Access Compliance Report Public Rights-of-Way (Curb Ramps)

Main Street: GERTRUDE_DR Cross Street: ARGYLE_DR Location: SE

ADA ID: RPRK211216114322 Ramp Type: Type 1 - Perpendicular Diagonal Initial Pass/Fail: Pass Overall Compliance: No Severity Score: 10

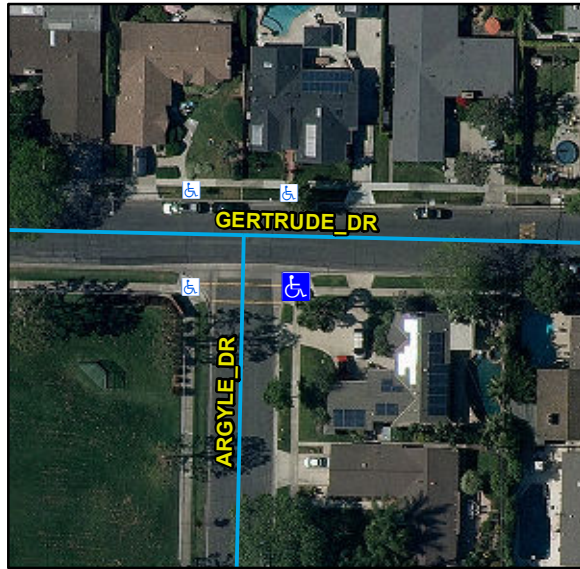
Remove & Replace Curb Ramp With Two New Directional Ramps or Equivalent. Gutter Ponding Observed.

Compliance	Description	Data	Compliance	Description	Data
N/A	Ramp Length (in)	84	N/A	Flare Type LT	
Yes	Ramp Width (in)	48			Sloped
Yes	Ramp Run Slope (%)	8.1	N/A	Flare Slope LT (%)	5.3
Yes	Ramp Cross Slope (%)	0.2	N/A	Flare Traversable LT	No
N/A	Landing Present	Yes	N/A	Flare Type RT	
N/A	Landing Length (in)	48			Sloped
Yes	Landing Width (in)	48	N/A	Flare Slope RT (%)	6.1
No	Landing Run Slope (%)	4	N/A	Flare Traversable RT	No
Yes	Landing Cross Slope (%)	0.4	No	DWS Provided	No
N/A	Landing Movement Obstructed?	No	N/A	DWS Contrast	N/A
	Landing Movement Type	N/A	N/A	DWS Length (in)	N/A
N/A	Landing Shared	No	N/A	DWS Full Width	N/A
N/A	Clear Space	Yes	N/A	DWS Offset Left (in)	N/A
N/A	Clear Space To Crosswalk (in)	48	N/A	DWS Offset Right (in)	N/A
N/A	Marked Crosswalk 1	No	N/A	Marked Crosswalk 2	Yes
	Crossing 1 Direction	N		Crossing 2 Direction	W
	Marked Crosswalk 1 Width (in)	N/A		Marked Crosswalk 2 Width (in)	120

N/A	Ramp Inside Crosswalk 1	N/A	Yes	Ramp Inside Crosswalk 2	Yes
	Crossing 1 Slope (%)	4.9		Crossing 2 Slope (%)	2.7
	Crossing 1 Cross Slope (%)	5.4		Crossing 2 Cross Slope (%)	3.6
No	Gutter Ponding	Yes	Yes	Curb Slope	1.3
Yes	Gutter Lip Height (in)	0		Road Run Slope (%)	0.9
Yes	Gutter Run Slope (%)	1.2		Road Cross Slope (%)	1.7
Yes	Gutter Cross Slope (%)	1.4			
Yes	Overall Surface Condition: Acceptable		No	Perp Joint Present	No
	Cross Gutter Present?	Yes		Spandrel Present?	Yes
	Replace Cross Gutter?	No		Replace Spandrel?	No

Possible Solutions:
